Re: Hawthorne at University Station Project Development Review

BETA Group has completed a review of materials provided for the Pulte Homes of New England application to site a 100 unit condominium in Development Area B of the University Station development. This letter includes BETA's findings and recommendations with regard to compliance with the Town of Westwood bylaws, and general engineering practice.

Hawthorne at University Station

MARK-UP OF ELEVATIONS AND PLANS
 ARCHITECTURAL PEER REVIEW
 BETA-DSK-KDG
 18 December 2017

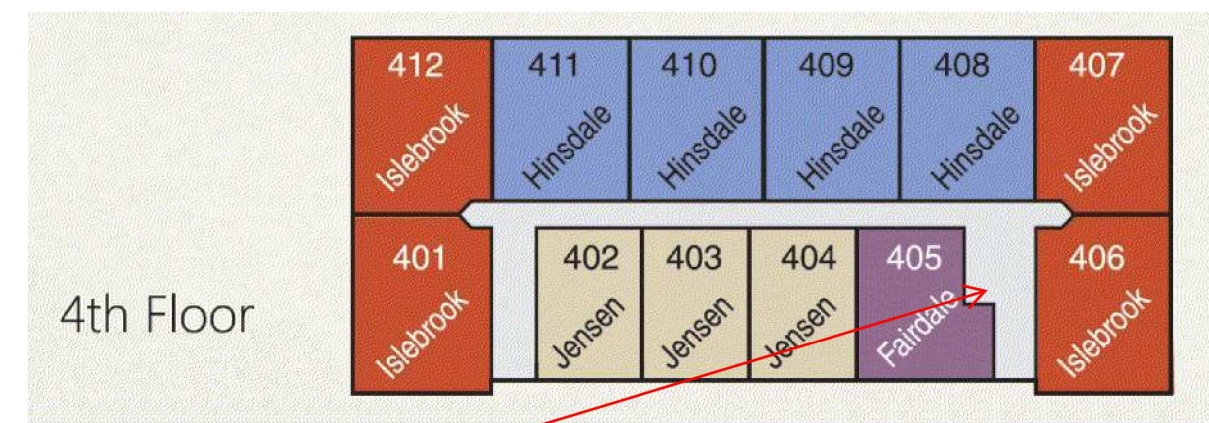
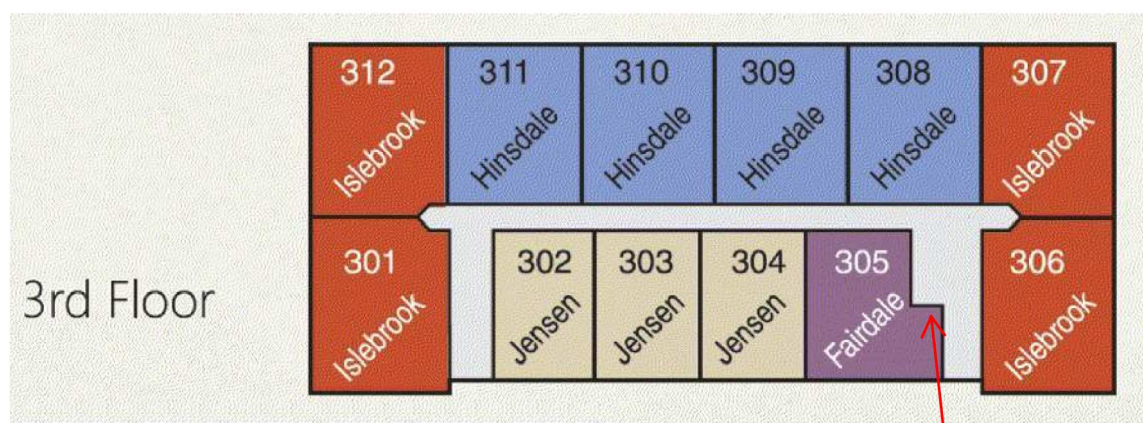
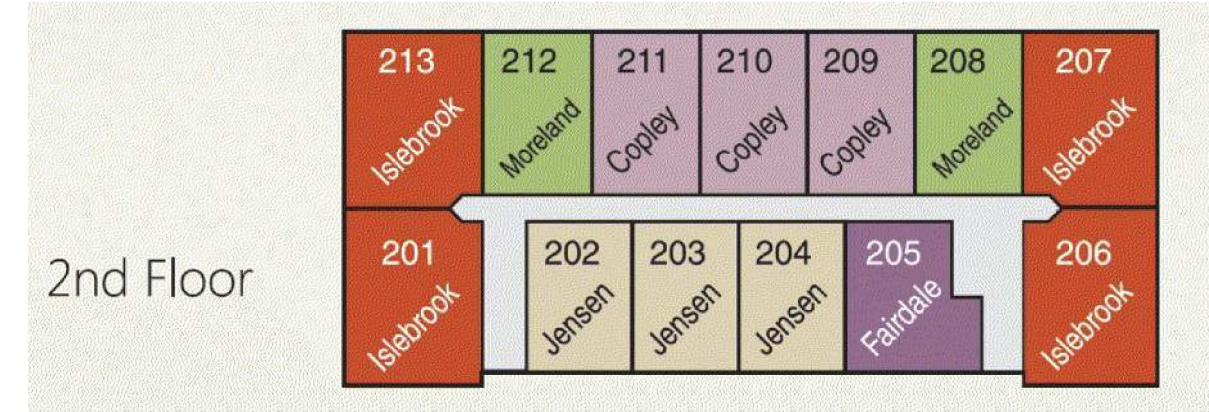
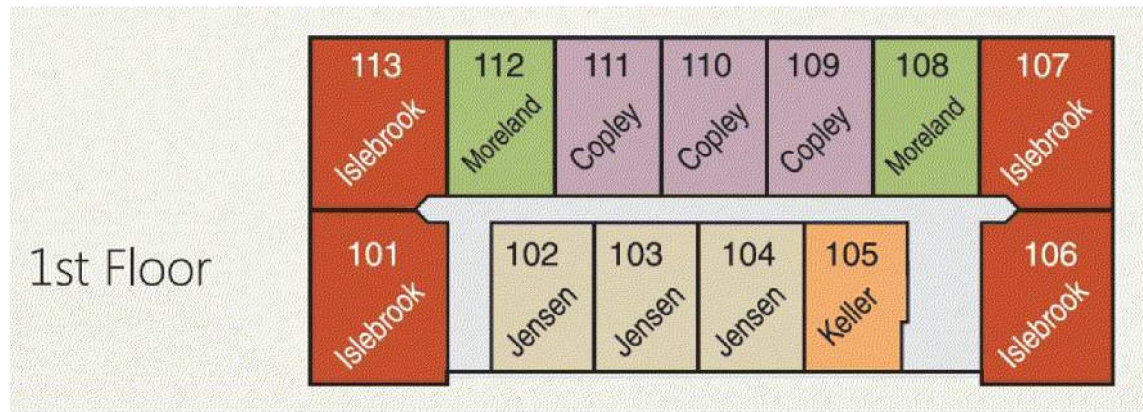
SIMPLIFY THE BALCONY HARDRAIL, TYPICAL

FLUSH FULL HEIGHT SIDE WALL, TYP

CHANGE/SHOW STAIR WINDOWS ON DOOR CENTERLINE, TYP

DARKER TOP FASCIA, TO MATCH STONE BASE, TYPICAL

EXTEND HEAD TRIM ACROSS TOP FASCIA, TYP

PAINT DOWN SPOUTS TO MATCH SIDING, TYPICAL

INCREASE PROJECTION OF BAY WINDOWS, TYP

ADD FACE TRIM TO COMPLETE MODULE, TYPICAL

REDUCE HEIGHT OF STONEMWORK, TYP
MULLED WINDOWS ON DOOR CENTERLINE, TYP
